REQUEST FOR QUOTATION Amendment #1 Monday March 09, 2026 - FINAL

RFQ Name: Replacement of Post and Rail Fencing at Regional Parks

RFQ NUMBER: RFQ-26003

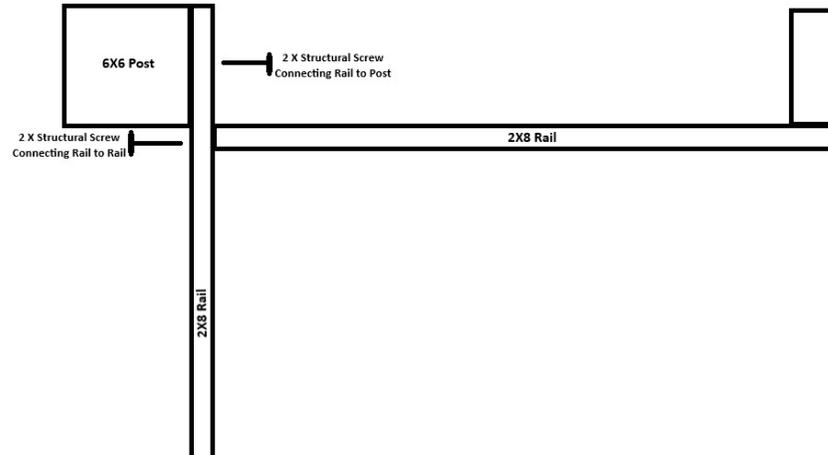
9. What is the length of the vehicle gate?

Refer to the maps as each vehicle gate have different dimensions.
